Index 711-003 Interchange Markings

COMMENTARY

COMMENTS AND RESPONSES

LAST REVISION 11/01/25	REVISION	DESCRIPTION:	 FY 2026-27 STANDARD PLANS	INTERCHANGE MARKINGS	INDEX 711-003	SHEET 6 of 8
---------------------------	----------	--------------	---	----------------------	------------------	-----------------

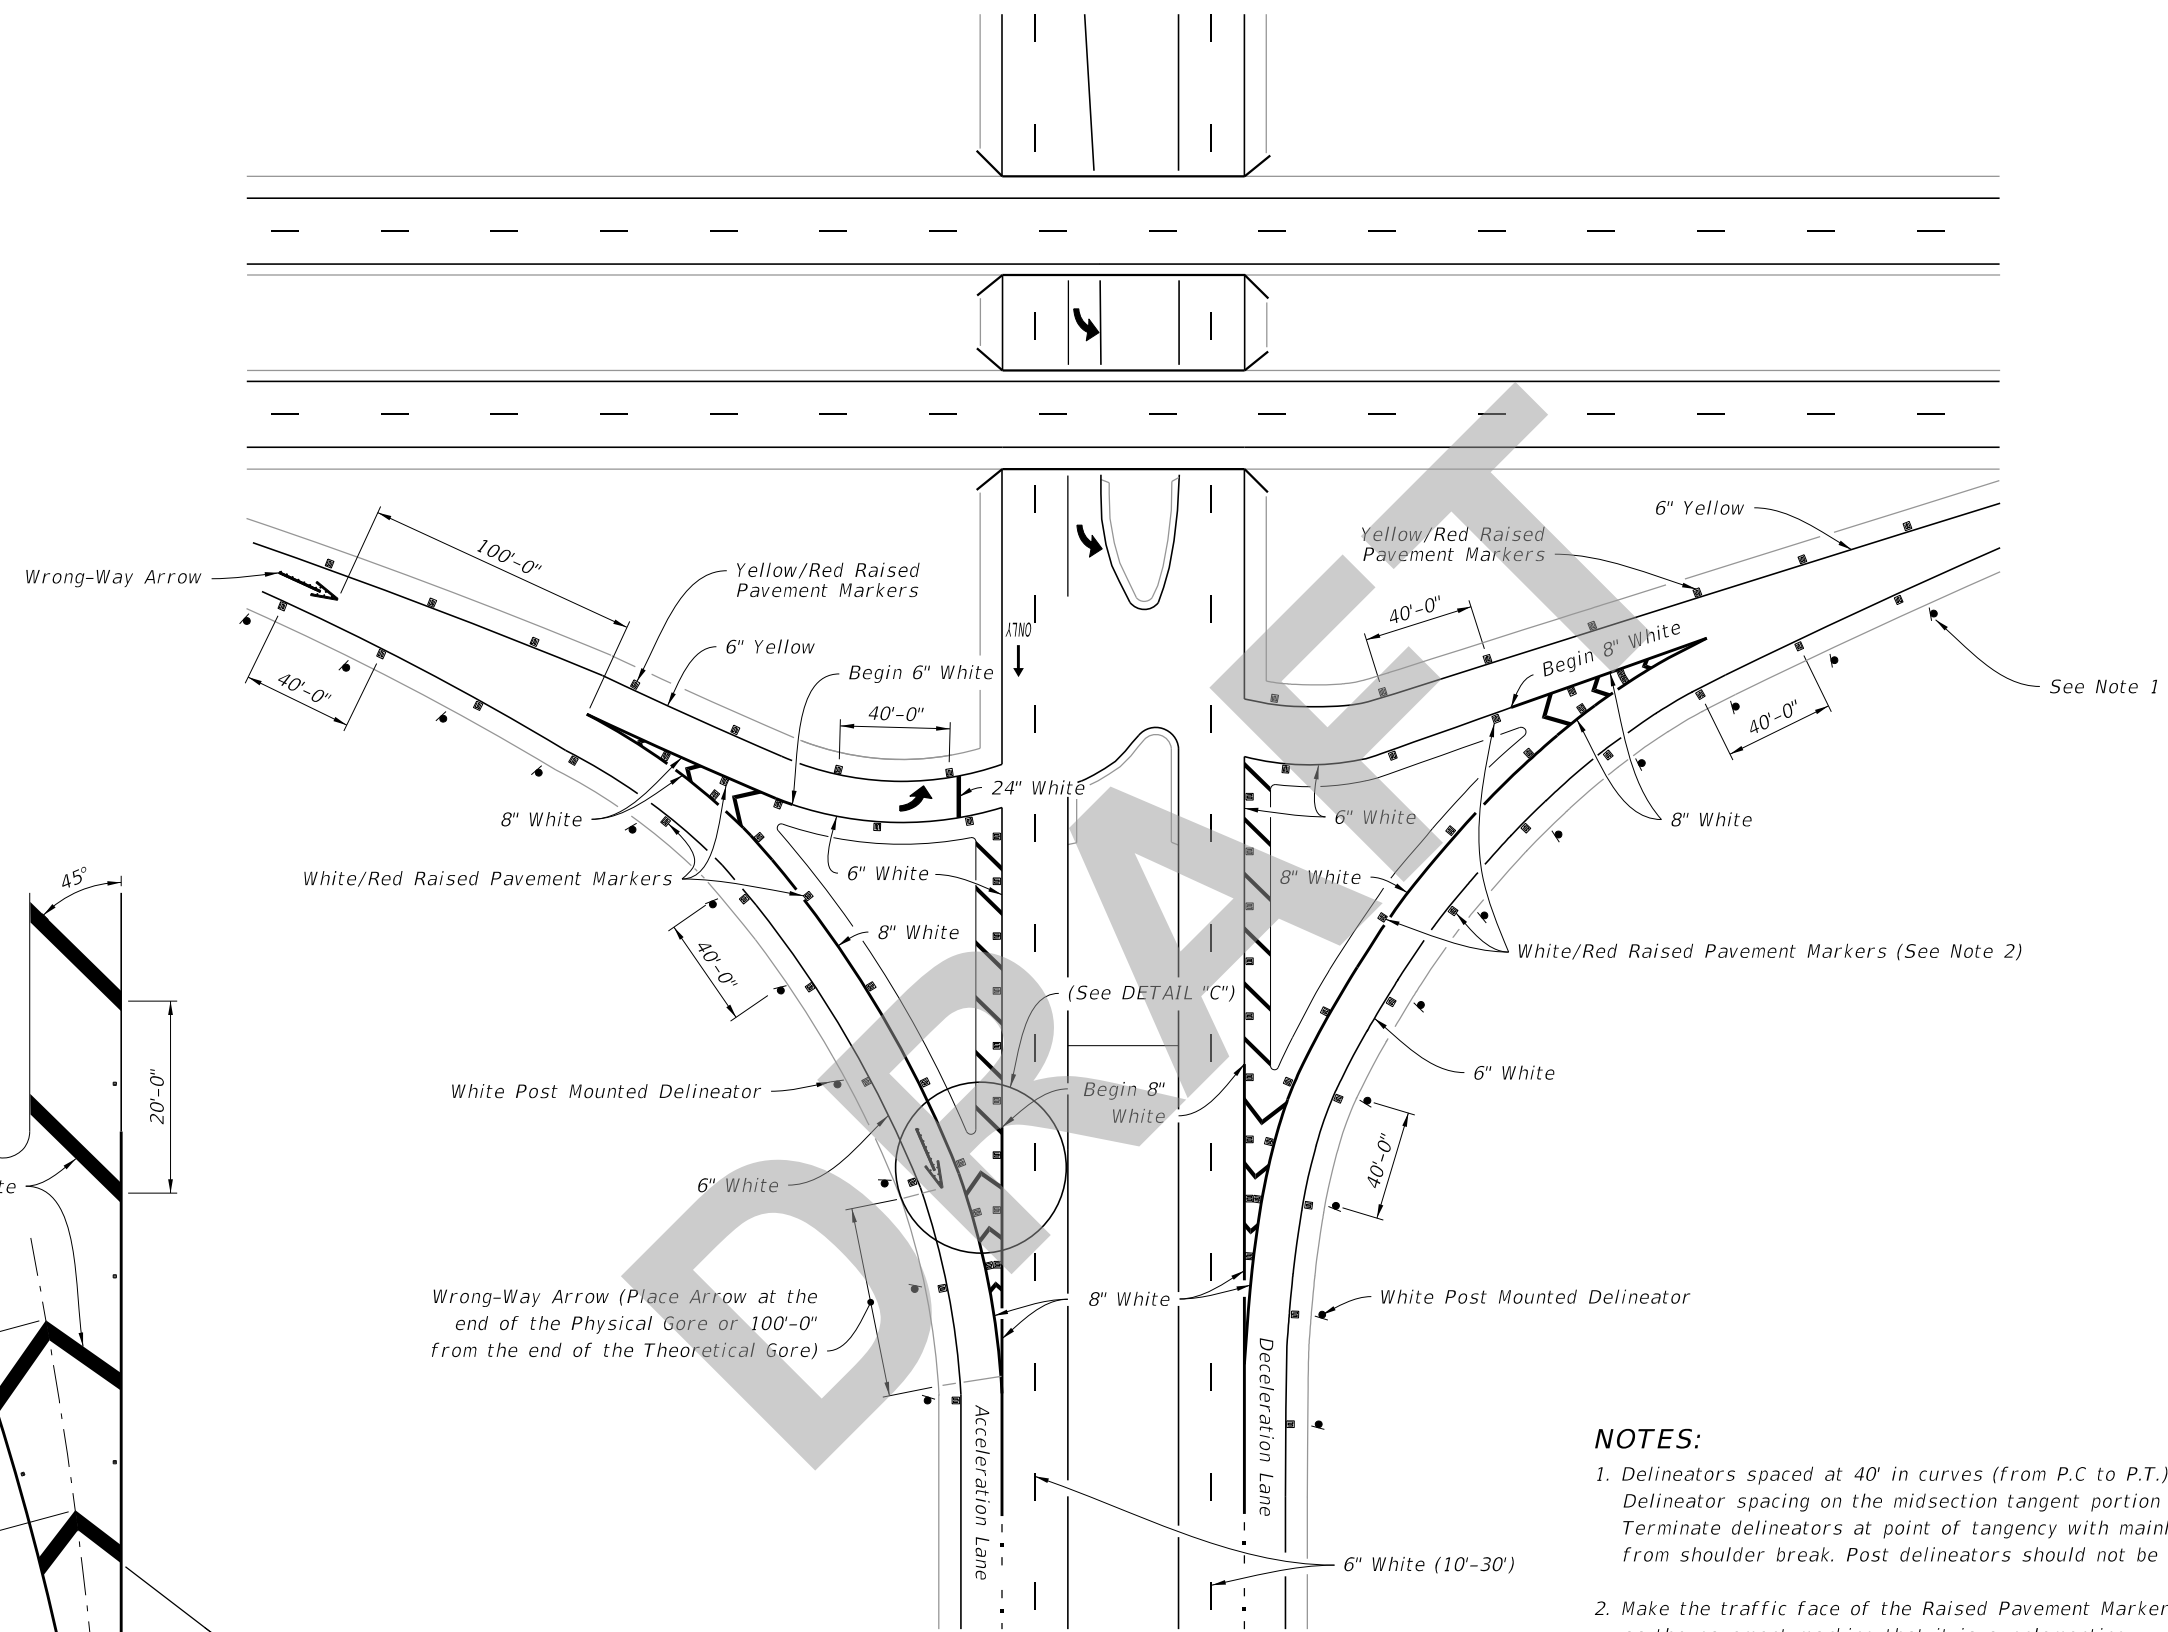
COMMENT: Can the note clarify if delineators should be used on both inside (yellow) and outside (white) for the entire length of the ramp. Or recommend the limits where it should start and end.

RESPONSE: Delineators are typically only required for one side of interchange ramps, but the other side can also be delineated based on engineering judgement. The limits of where the delineators start and end are discussed in Note 1, however, it may be beneficial to clarify the "last" P.T. as the point of tangency with the mainline instead.

CHANGE MADE TO INDEX: Yes. Updated Note 1 language to "point of tangency with mainline" rather than "last P.T."
